Sea Link

Volume 9: Examination Submissions

Document 9.136: Applicant's Responses to Third Written Questions

Planning Inspectorate Reference: EN020026

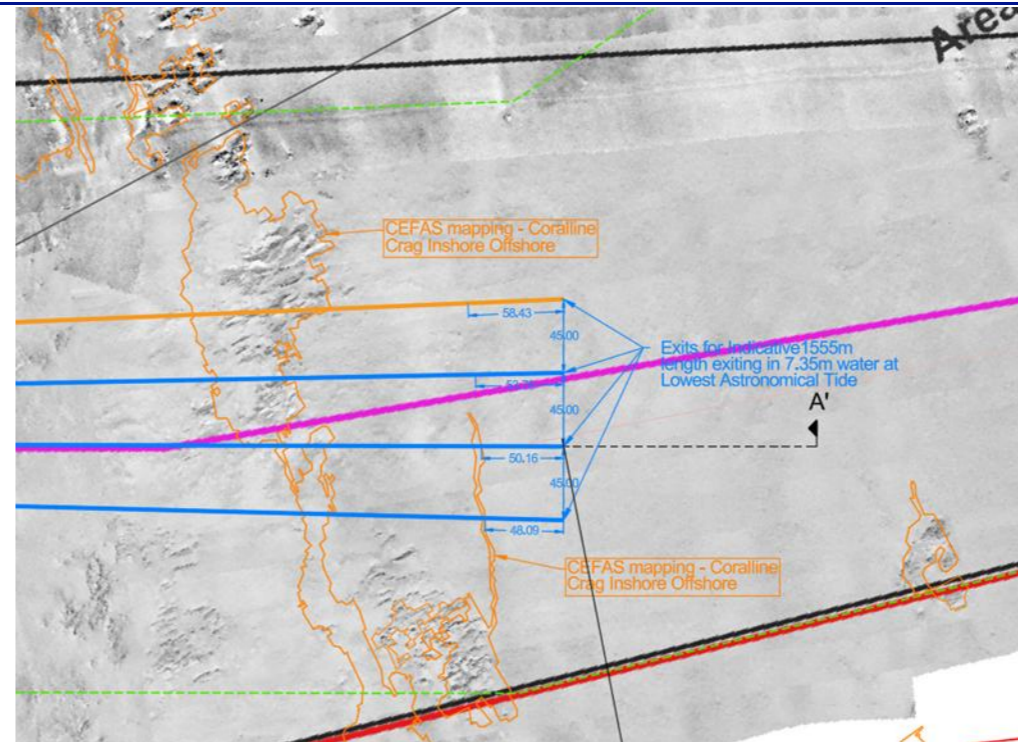
3PE3.	Applicant	Coralline Crag mapping Provide more detailed/higher resolution mapping/chart information to enable greater resolution of the proposed HDD exit locations.	<p>The Applicant confirms that the existing Cefas mapping is based on surveys conducted in 2016 and 2018 using multibeam and side scan sonar data. The Applicant's recent 2023 offshore survey data (Application Document 9.80) confirms the Cefas mapping extents, although the thin spur of Coralline Crag is absent from the Applicant's most recent surveys. The Proposed Project's 2023 offshore survey shows sand 45m west of the HDD exits, whereas CEFAS show the thin spur of Coralline Crag. Therefore, the Cefas mapping is being taken as the current 'worst-case' and the commitments within the REAC have been based on this worst-case extent of the Coralline Crag outcrop.</p> <p>Plate 2.3 in 9.113 (A) The Coralline Crag Technical Note [REP4-102] (also provided below) shows the difference in the bathymetry between the CEFAS Mapping and the Proposed Project's 2023 data.</p>

The Applicant will conduct and review pre-construction survey data to confirm the extent of the Coralline Crag outcrop prior to starting works. These surveys are already secured within the outline In-Principle Monitoring Plan (**Application Document 9.140**), outline Cable Specification and Installation Plan (**Application Document 9.92**) and outline Construction Environmental Management Plan (**Application Document 7.5.2**) under Condition 4 of the dML to ensure that the existing REAC commitment GH14 is adhered to.

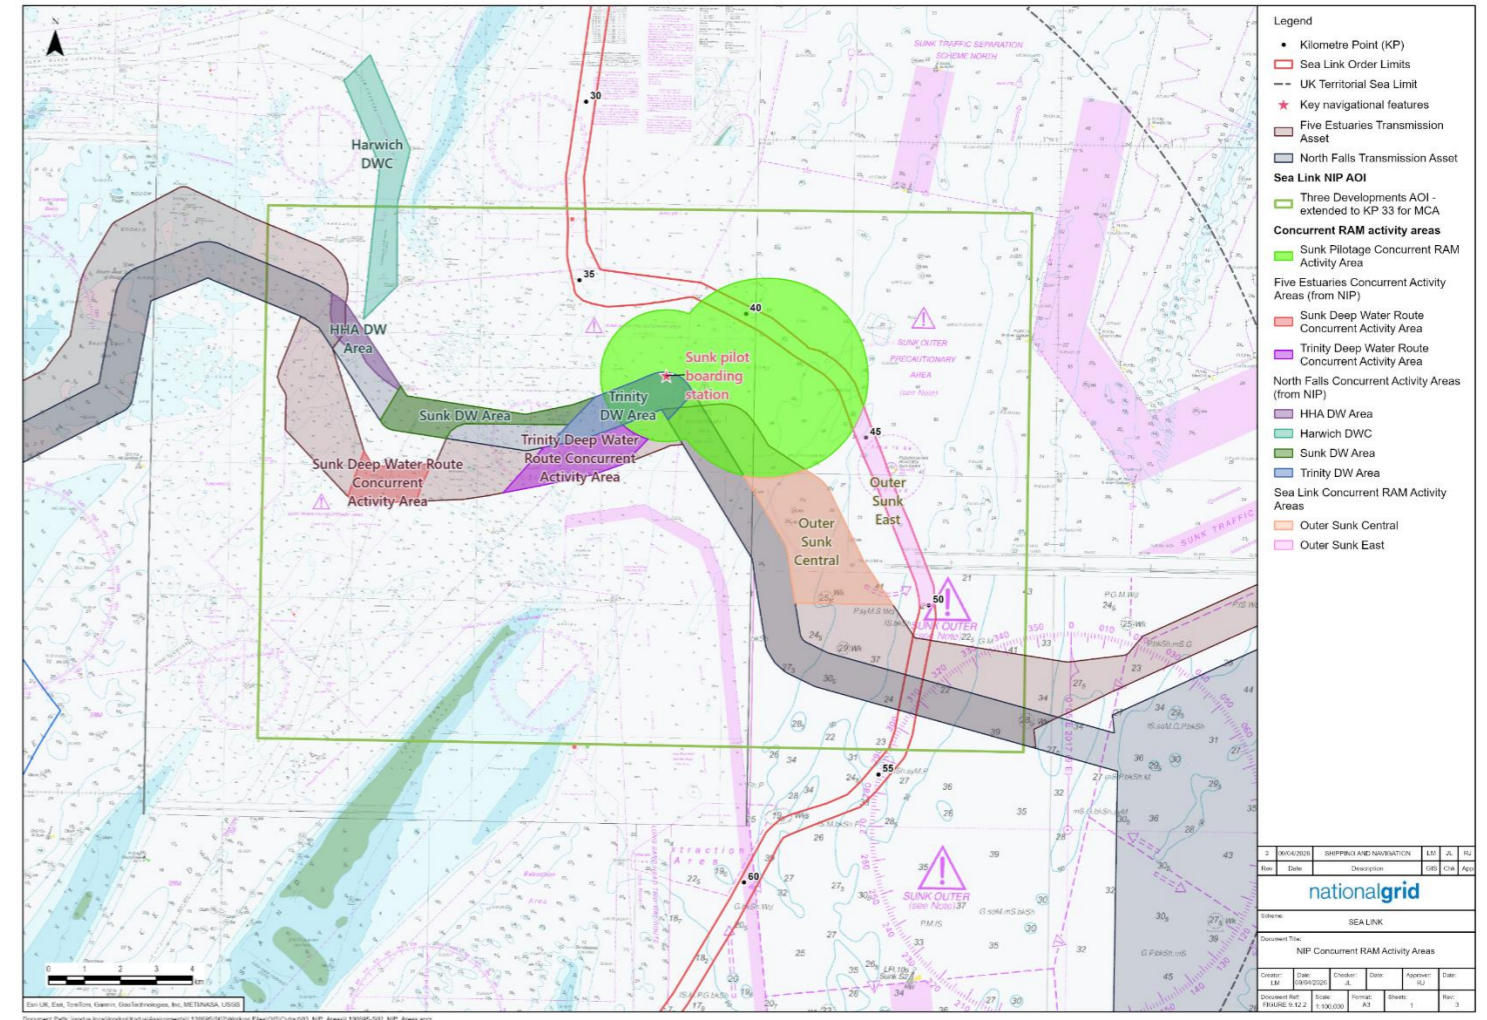
Reference	Question to:	Question	Applicant's Comments
3SN1.	Applicant Maritime and Coastguard Agency (MCA)	<p>Concurrent restricted in ability to manoeuvre (RAM) vessel activities</p> <p>Maritime and Coastguard Agency (MCA):</p> <ul style="list-style-type: none"> • Explain whether there has been a change in circumstance that has led to the request for an enlarged area of interest (set out in figure 1 of your response to ISH2.09 in [REP4-164] and your response to action points in [REP4-165], if so, provide any additional information to explain what has led to the change in circumstances. • Explain the implications of concurrent RAM vessel activities in terms of safety and the economy and whether any residual effects would be significant/ As Low As Reasonably Practicable (ALARP). • Provide suggested wording and plans to secure the concurrent RAM restrictions that the MCA seeks and the means of securing it, whether through the dDCO/dDML or a control document such as the Outline Navigation and Installation Plan (oNIP). <p>Applicant: Clarify the implications for the proposed development of restricting concurrent RAM activities in the area of interest requested by the MCA.</p>	<p>The Applicant confirms that a call was held with the MCA on 30 March 2026 to discuss their request for additional 'concurrent RAM and Restricted Visibility Stop SimOps Areas' and associated commitments. The further MCA clarified that in terms of concurrent RAM activity areas their concern relates specifically to risks associated with maintaining sea room in the south.</p> <p>In addressing this concern and others the Applicant has,</p> <ul style="list-style-type: none"> • Added two additional concurrent RAM activity areas, 'Outer Sunk East' and 'Outer Sunk Central', to Plate 3.1 (provided below for ease) and associated commitments in section 3.3 of the oNIP, to directly address the MCA's concern regarding risk associated with adequate sea room to the south. • Added the relevant concurrent RAM activity areas for North Falls and Five Estuaries to Plate 3.1 to illustrate Sea Link's coordinated approach to concurrent RAM operations within the Sunk region; noting that only some of these areas are directly relevant to Sea Link. • Added a section 3.4 to the oNIP dealing with 'Weather Constraints and a HAZOP Workshop' including the clause 'The HAZOP workshop will also define weather limits, and associated risks to project vessel and/ or third-party vessel operations, including visibility thresholds (2 Nautical Miles)'. This is to directly address the MCA 'Restricted Visibility Stop SimOps Areas'.
